12th Street Landing PDSP Amendment

Long Range Planning Committee (LRPC) Meeting #1

Site Plan #105

601 & 701 12th Street South

Staff Assessment – Proposed Building Heights

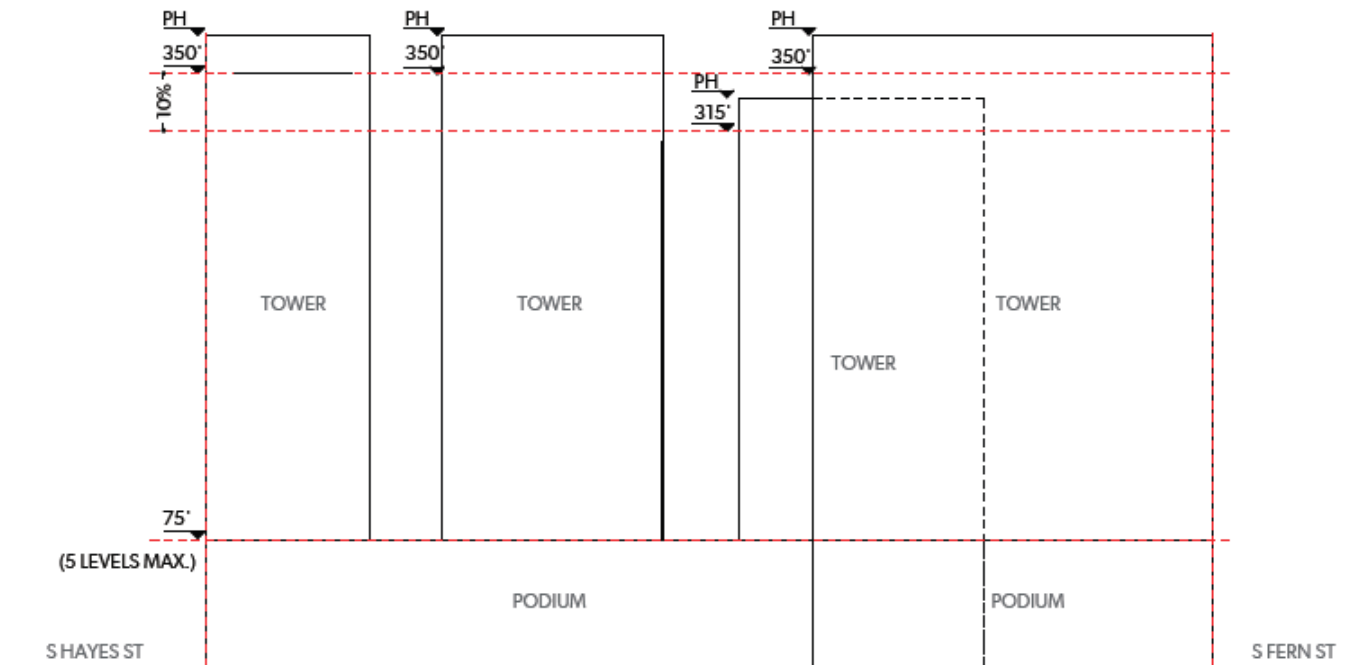
- Sector Plan
 - Max. 350 feet excluding penthouses, mechanical, parapets, architectural elements;
 - 10%-20% variation between at least two buildings

- From developer's proposed draft design guidelines:

Staff Assessment – Proposed Sustainability

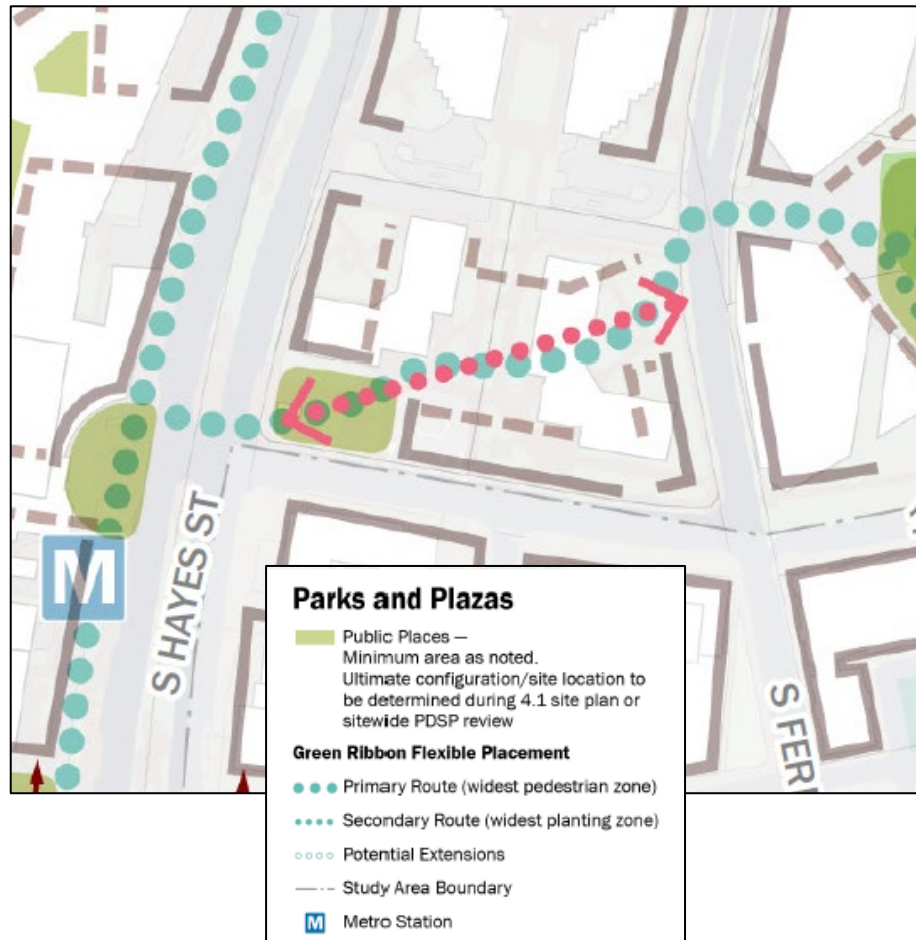
Proposed Design Guidelines

1. Sustainable, resilient, and biophilic design*
2. Buildings designed to LEED Gold*
3. Compliance with the Arlington County 2020 Green Building Incentive Policy**
